CONSTRUCTED IN
PARCEL MAP 8705
PRIVATE CONTRACT NO. 9509

W.S. 39-A-3
 2 SHEETS; 4 PAGES
 SCALE: VERT. 1"=4'
 HORIZ. 1"=40'
 FEB. 15, 1978
 PREPARED IN THE OFFICES OF
JAMES O'MALLEY AND ASSOCIATES
 CIVIL ENGINEERS
 (714) 634-3363
 BY: *James O'Malley*
 REG. C. E. NO. 27217

COUNTY OF LOS ANGELES, CALIFORNIA
 STEPHEN J. KOONCE - COUNTY ENGINEER JOHN D. PARKHURST, CHIEF ENGINEER
 APPROVED: *B.F. Norling* REGIONAL ENGINEER APPROVED: *James O'Malley* ASST. OFFICE ENGINEER
 CHECKED: *Thomas E. Howard* DATE: 12/15/78 REG. C.E. NO. 19124
 LA PUENTE BLDG. DIST. 2 J.N. 0250-05

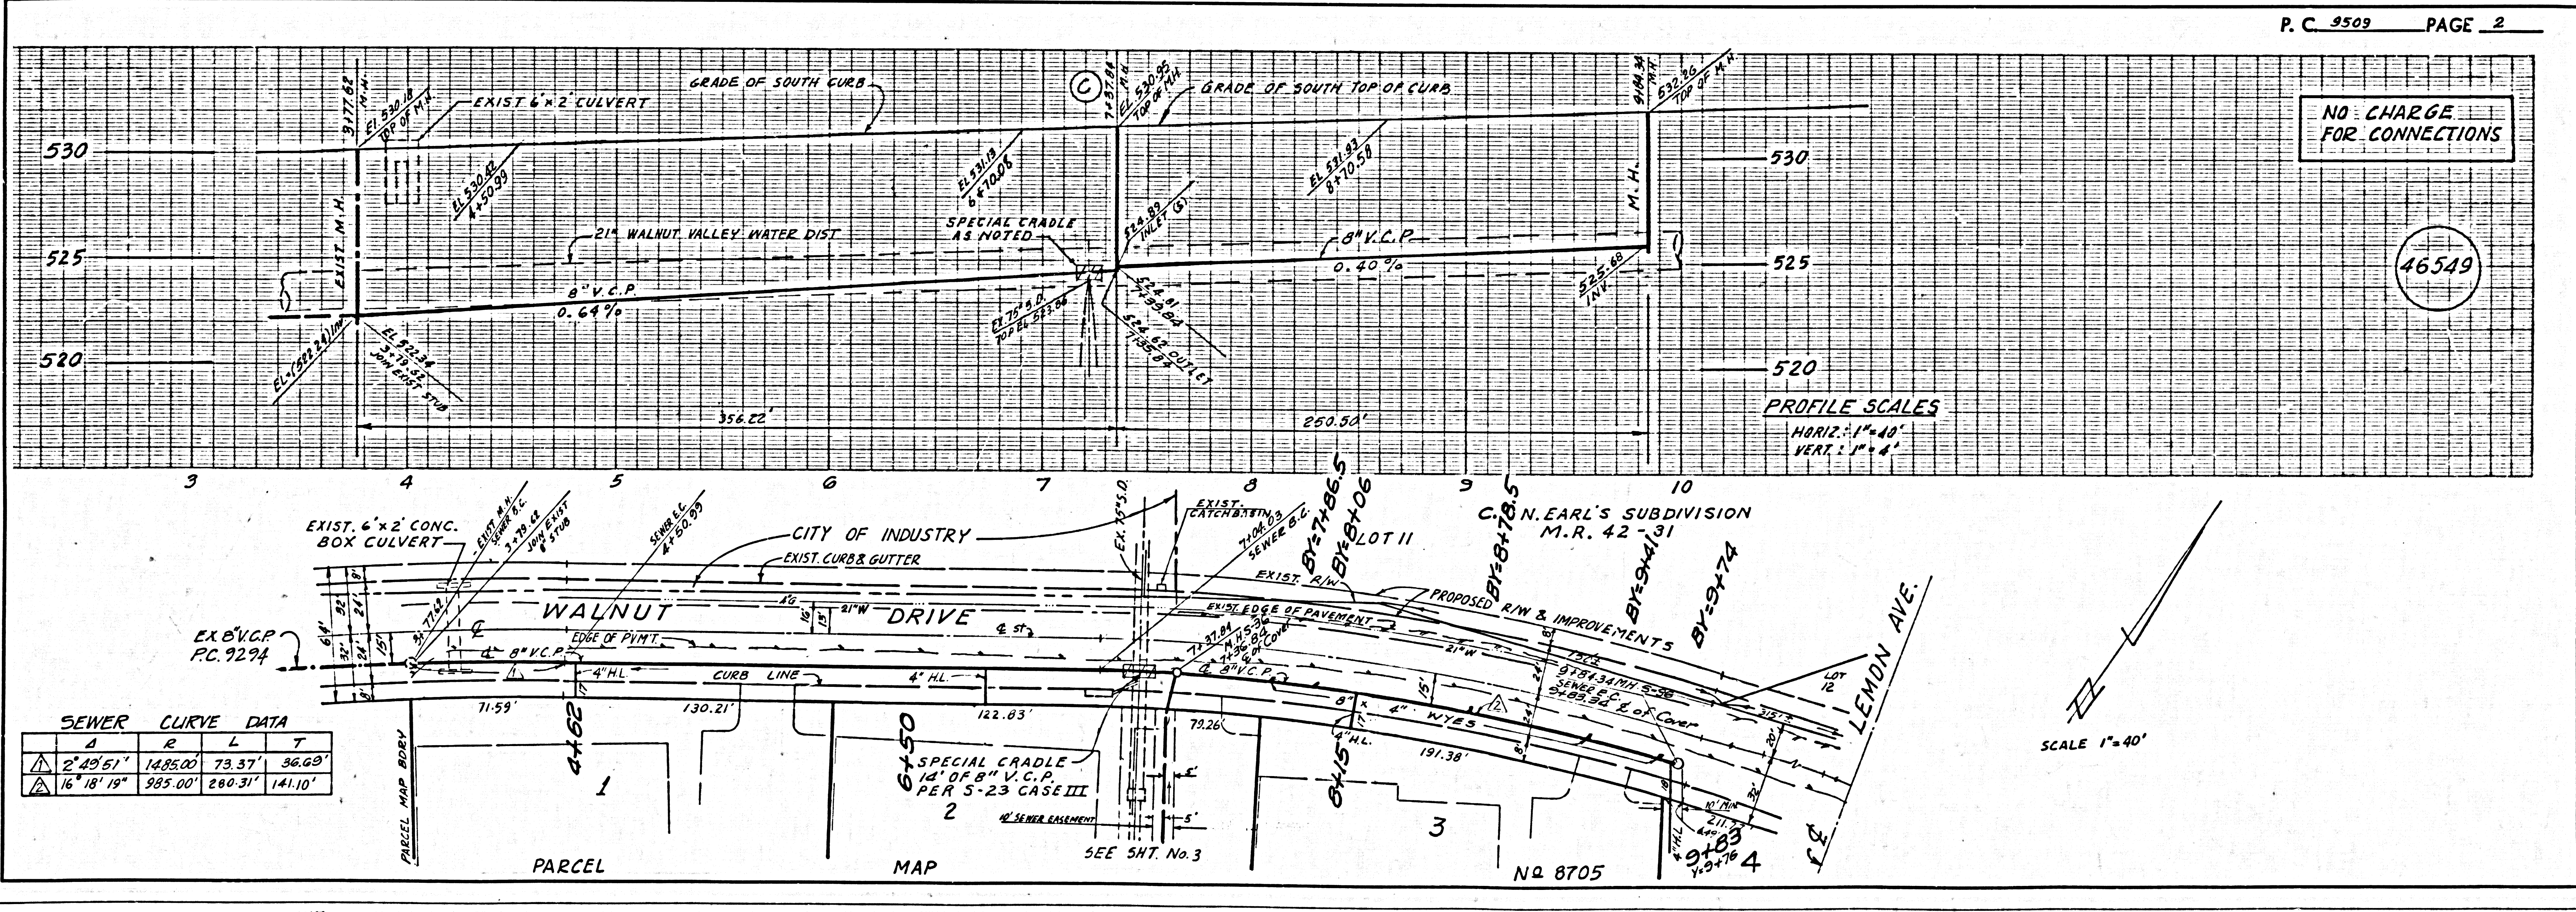
REVISION NO. 1 DATE: JUNE 21, 78
 1. Page 4A- Revised vertical and horizontal alignment of line from Sta. 0+00 to Sta. 1+97.
 2. Page 4B- Revised vertical alignment of line from Sta. 0+00 to Sta. 0+93.82
 APPROVED: *B.F. Norling* 6-21-78
 OFFICE OF COUNTY ENGINEER RE. NO. 11638

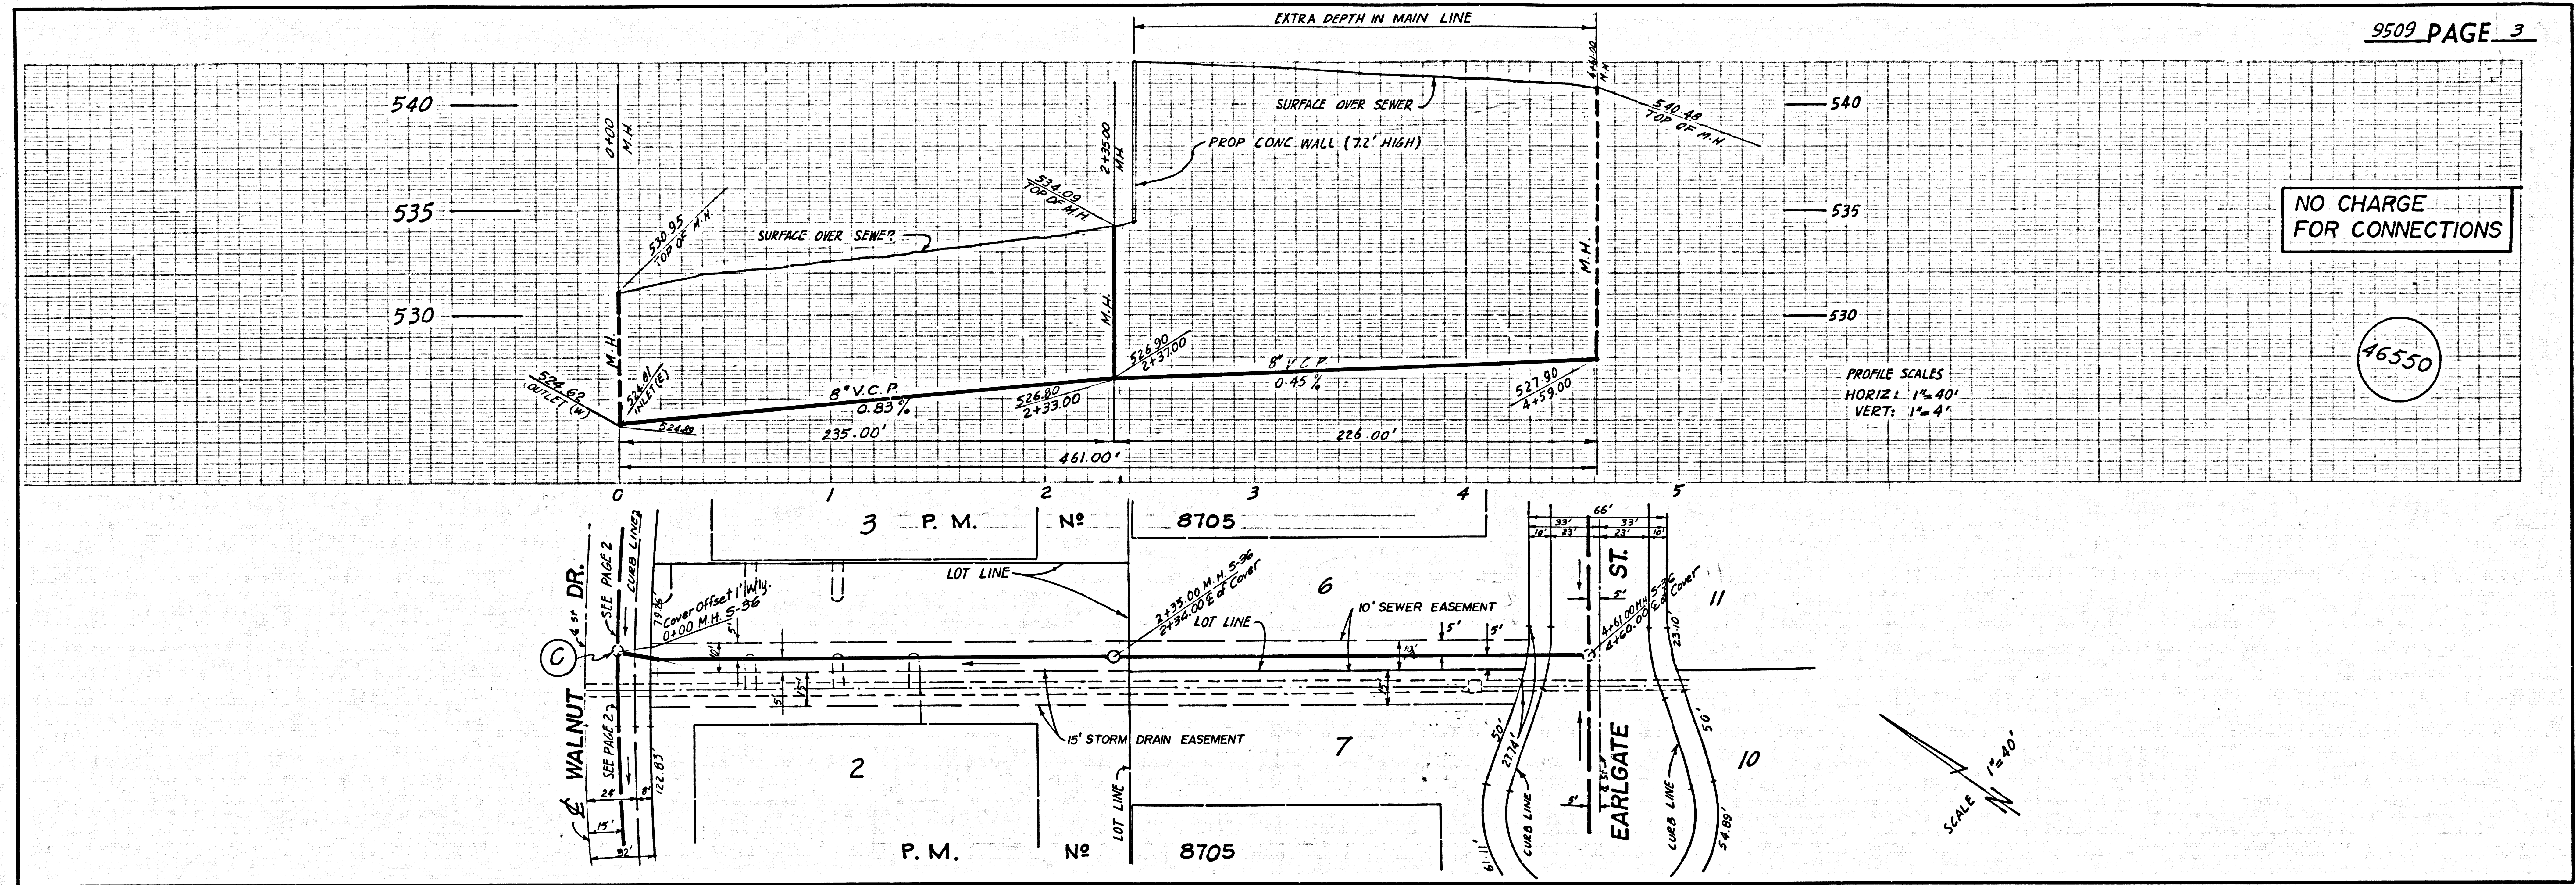
REVISION NO. 2 DATE: NOV. 9, 78
 1. Page 2 and 3C- Moved M.H. 4 feet E/W to Sta. 71.97.84 and revised elevations
 APPROVED: *James H. Mellow* 11/9/78
 OFFICE OF COUNTY ENGINEER
